HumeLink Alliance Incorporated
Andrea Strong
"Rockpools"
156 Alton Hill Road
Gunning
NSW, 2581

**SUBMISSION IN RESPONSE TO THE ENVIRONMENTAL IMPACT STATEMENT OF THE
VNI WEST PROJECT – APPLICATION NO SSI-72887208**

We welcome the opportunity to make a submission to the Victoria to NSW Interconnector West (VNI West) Environmental Impact Statement (EIS).

Figure 1a: VNI West – EIS Main Report Front Cover

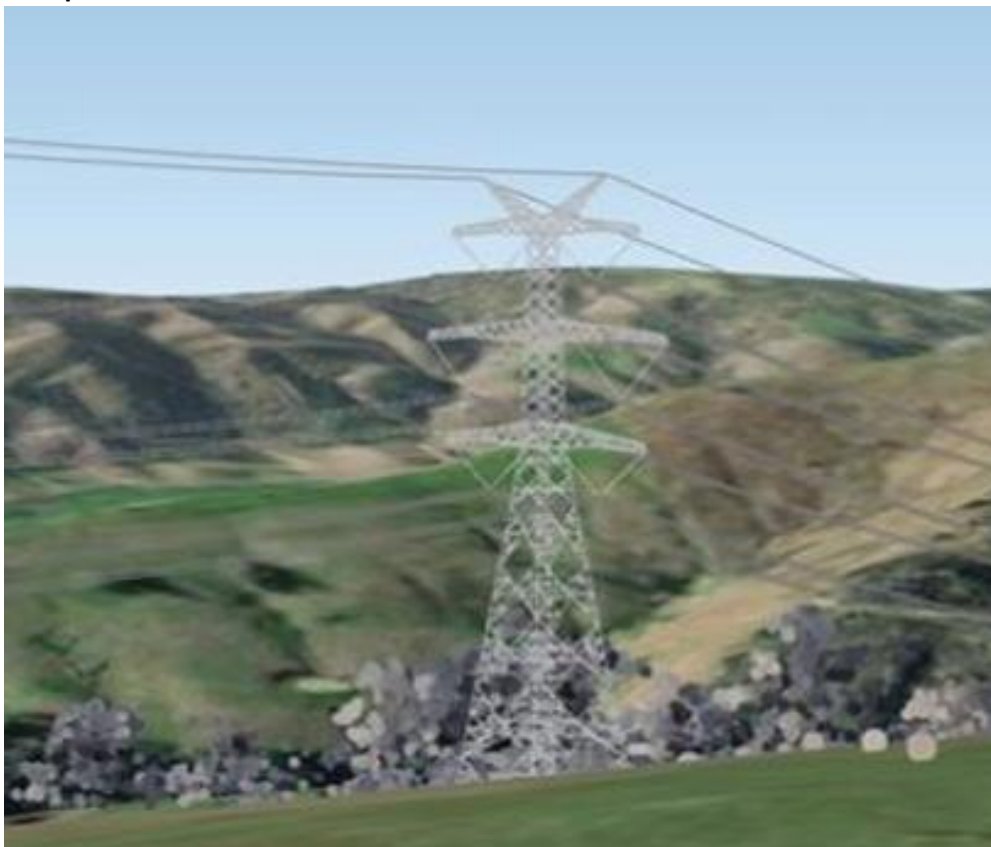
Perhaps the most egregious failure of the VNI West EIS is the misleading image on the front cover of the Main Report of the EIS, where small shrubs are shown screening the up to 80m tall 500kV towers of the VNI West transmission line, see Figure 1a.

Figure 1: Comparison of 500kV and existing 330kV transmission lines

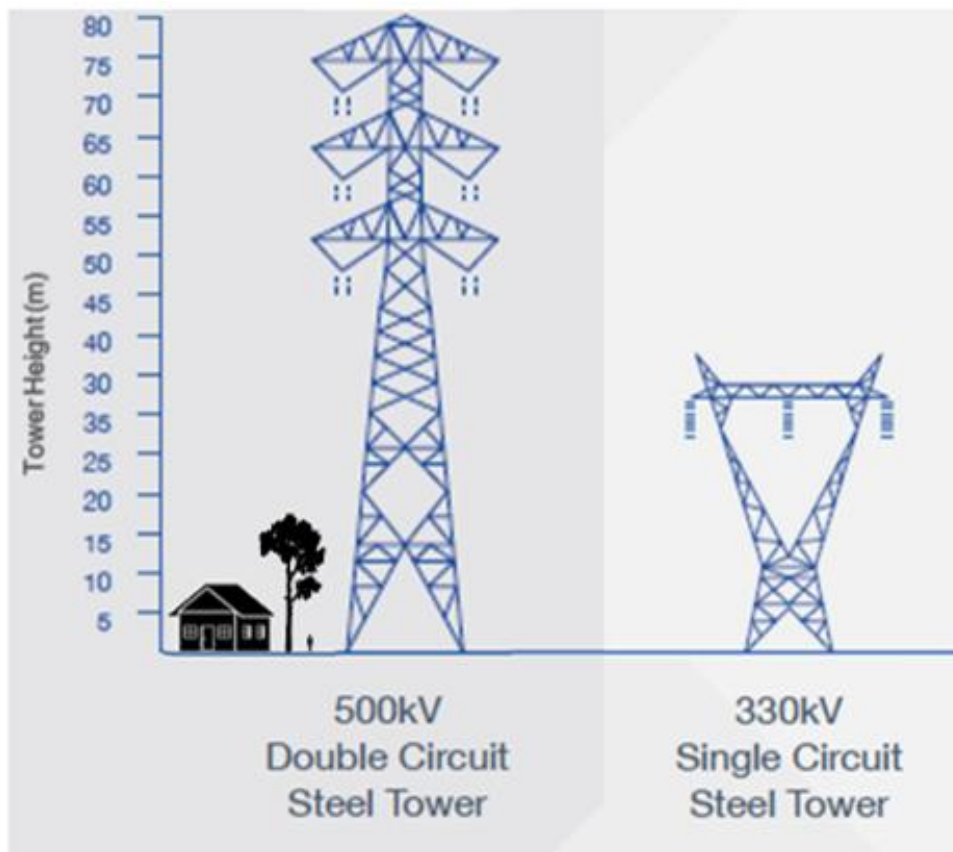
An indication of the visual and landscape character impacts of 500kV overhead transmission lines, is provided in Figure 1 below, that shows the height of the towers relative to a 6'6" person, an 8m dwelling, a tree and existing 330kV transmission lines in the landscape.

Figure 2: Impacts of concern from overhead transmission lines and underground cables

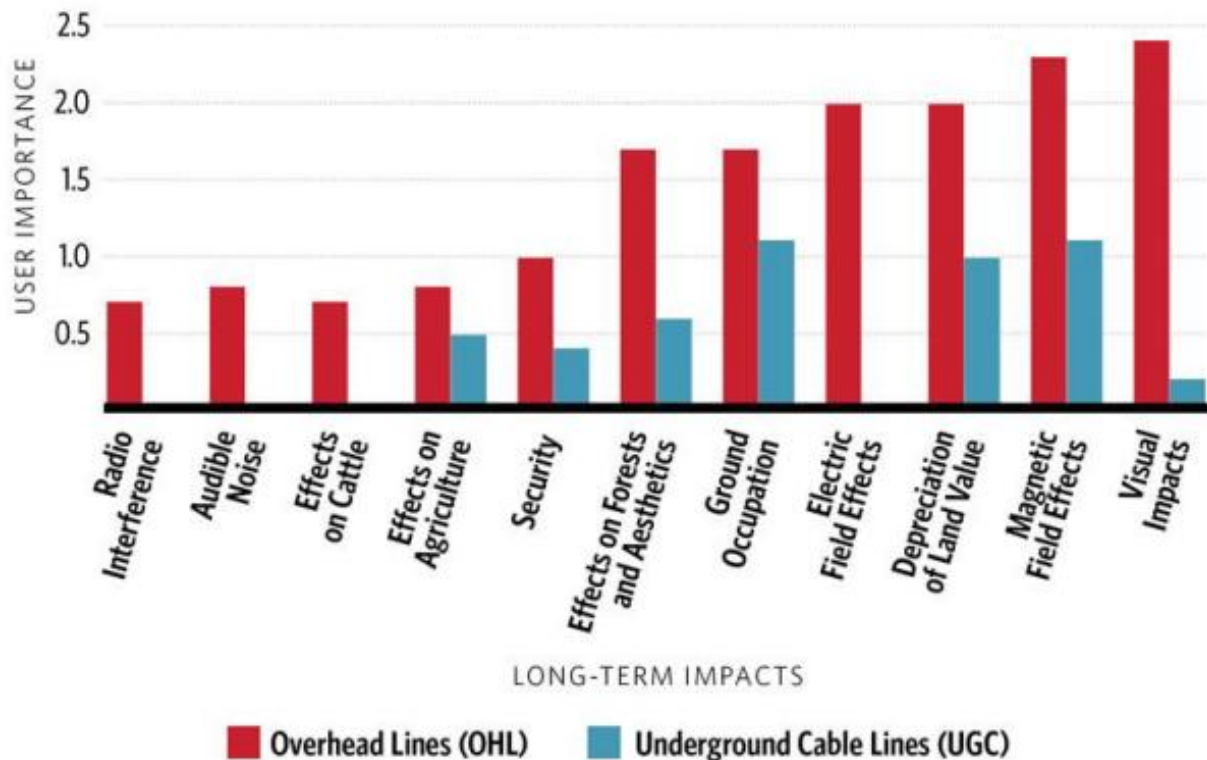
Although Transgrid implies there are problems for landowners with underground cables, an international study indicates there are important benefits, see Figure 2 below.
